April 27, 2009

Michael Rosauer
California Public Utilities Commission (CPUC) c/o Dudek
605 Third Street
Encinitas, California 92024

Re: Sacramento Natural Gas Storage (SNGS) Project
CPCN Application No. 07-04-013
State Clearing House No. 2007112089
Comments for April 28 Public Hearing
Comments on Draft Environmental Impact Report (EIR)

Figure 1.

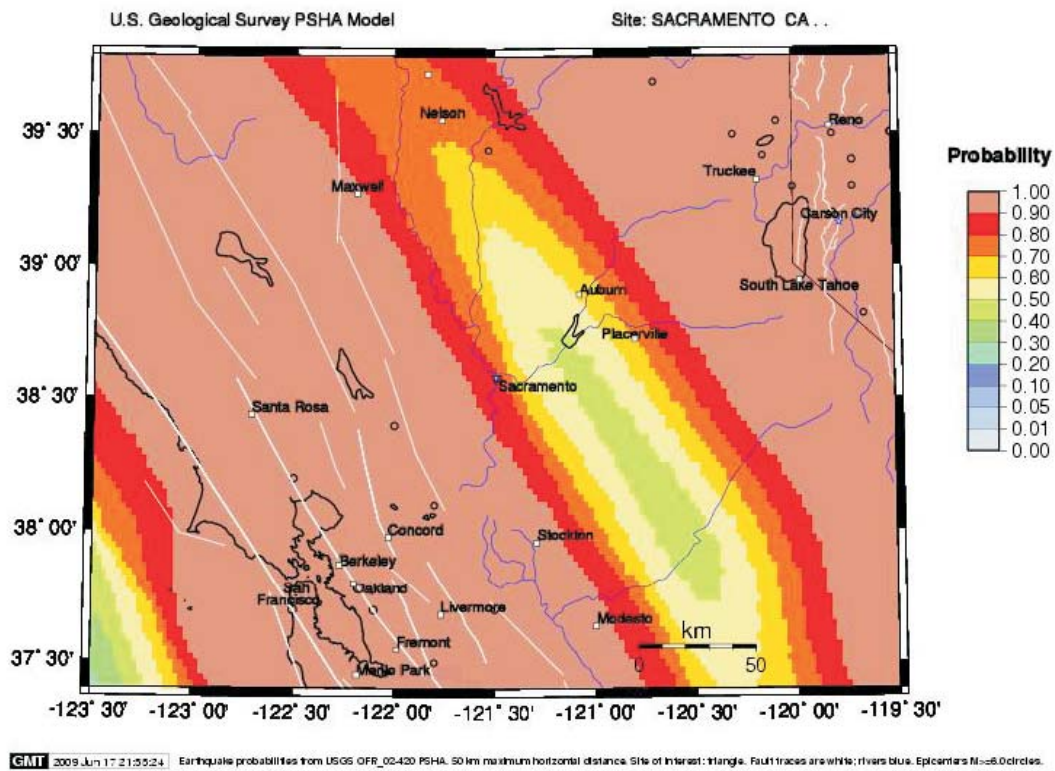
The chances of seepage of gas into the aquifer or into the air may be low, but it is not of such low probability so as to render it an insignificant risk. In fact, a review of the USGS website for earthquake probabilities in areas throughout California shows that the probability of a seismic event of magnitude 5.0 in the Sacramento Area – an earthquake of sufficient force to cause subsurface rock to fracture – is high enough as to be termed "significant". Figure 1, below, depicts the probability of a significant earthquake (5.0) occurring in the Sacramento region within the next 100 years as 0.8 (an 80% chance that one of this magnitude will occur). This type of analysis is required by CEQA, yet is lacking in the DEIR.

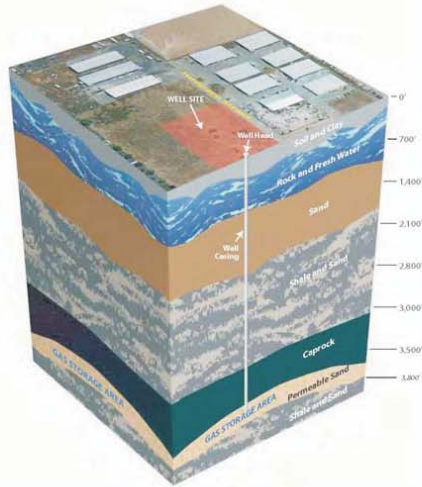
B. P-9 Comment: The Section D.11 does not discuss the presence of the 100-ft wide overhead power line immediate adjacent to the wellhead site and the possible at-risk of involvement of the towers of the powerline in the event of a torch/cloud-fire at the wellhead site.

p. 3, Figure 1. Florin Field, Geological Model

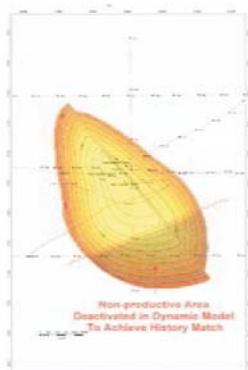
RS063008 RS-15 Comment: This Letter Report revises the 2007 RSC report and further develops various scenarios based on the original hypothetical RSC model of the Florin Reservoir. As the original model did not perform properly for the gas storage reservoir, the Applicant had RSC revise the model and development. The use of "latest prediction scenario" represents a contradiction as without any direct and current data and information regarding the "reservoir" and no way to verify initial or revised pressures on a hypothetical model, no "predictions" can be undertaken.
